Sundry Print Report

Well Name: CHACON JICARILLA

Type of Action: Plug and Abandonment

CONDITIONS OF APPROVAL

P&A WBD Proposed

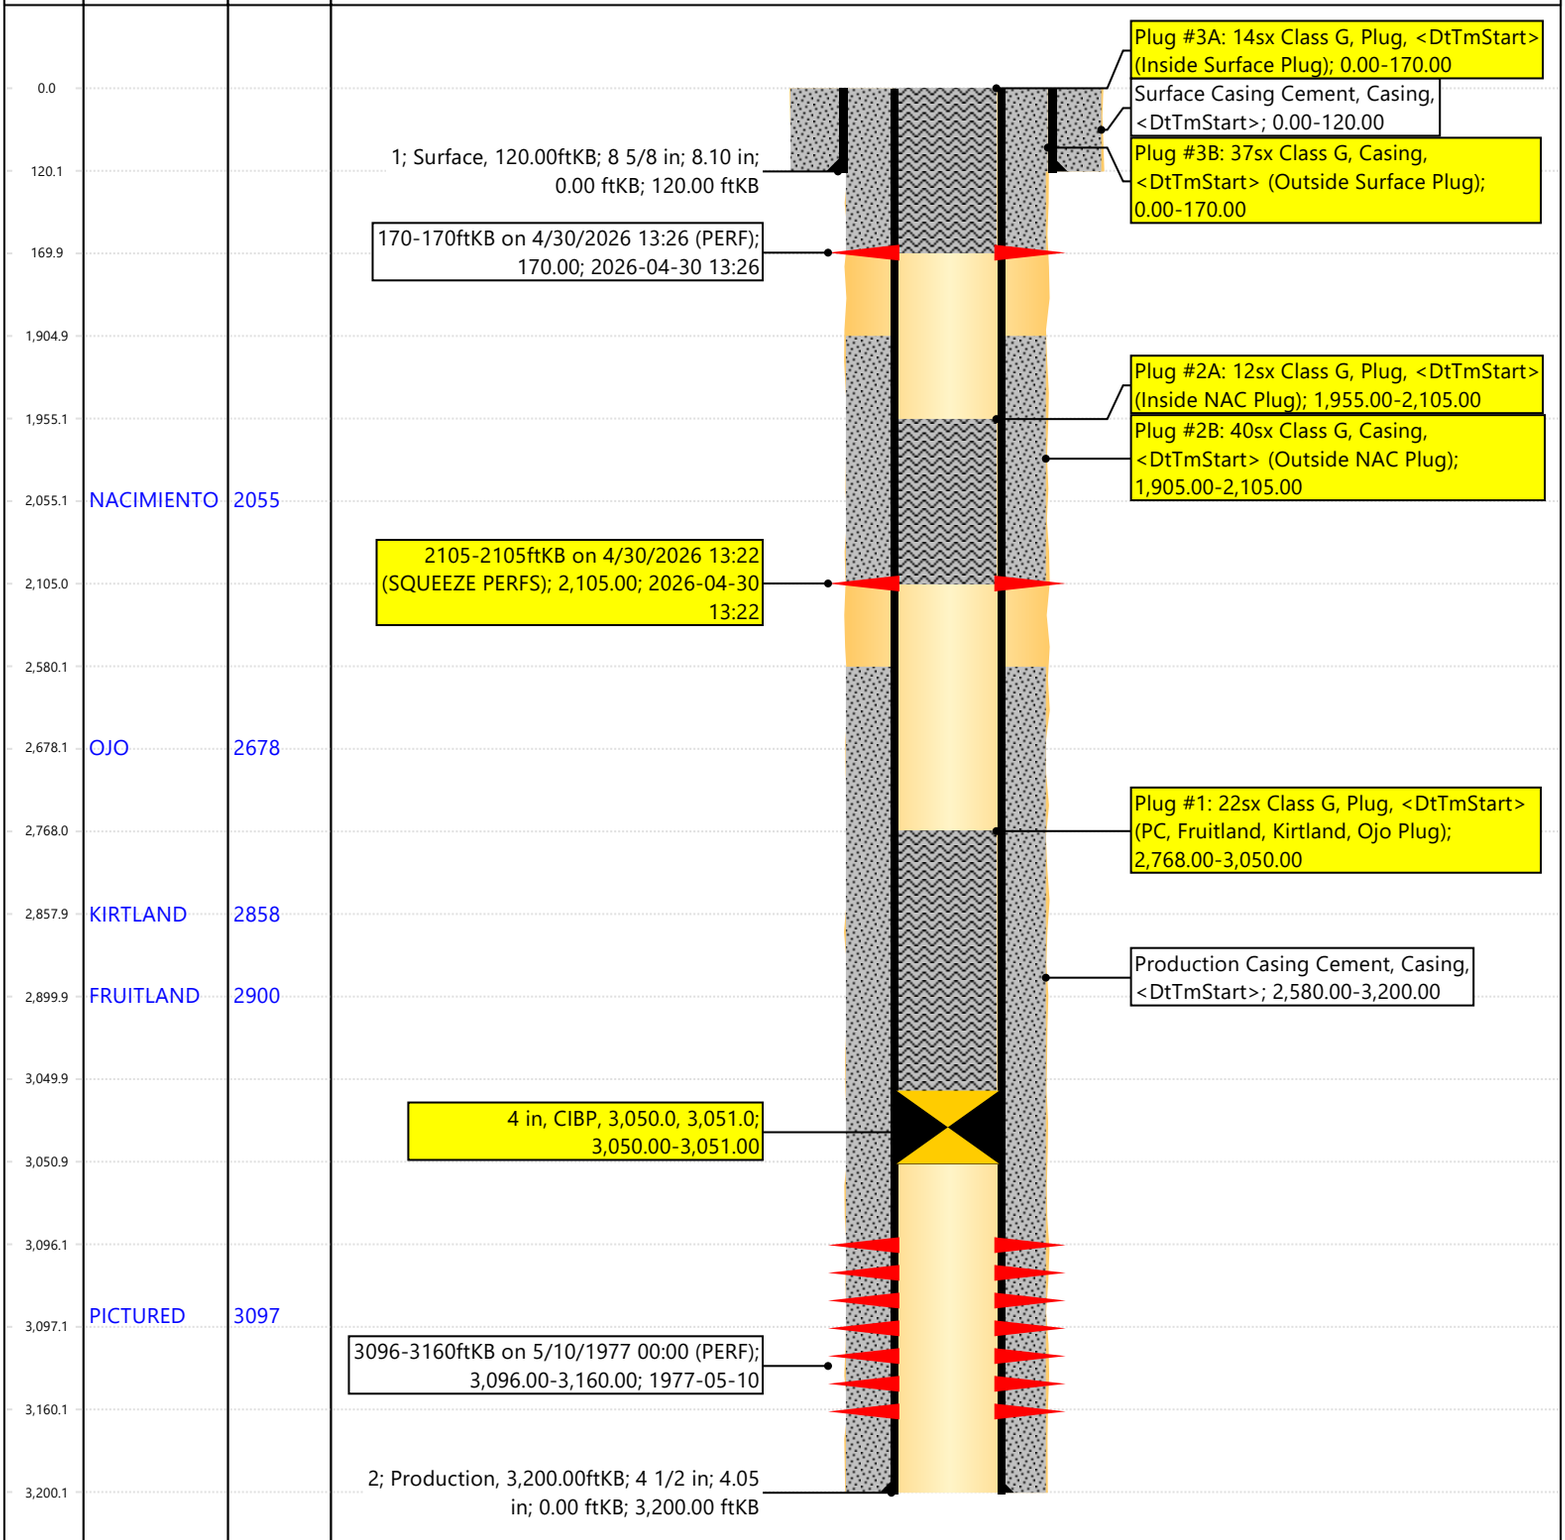
a. Modify Plug 1. The CIBP/CICR should be set at ± 3046' and the TOC at 2578' to account for BLM regulations.
   a. Confirm surface casing setting depth. The available completion reports have 139', the procedure has 120'. If 139', modify plug 3 to cover 50' below surface casing shoe.

- Modify Plug 1. The CIBP/CICR should be set at ± 3046' and the TOC at 2578' to account for BLM regulations.
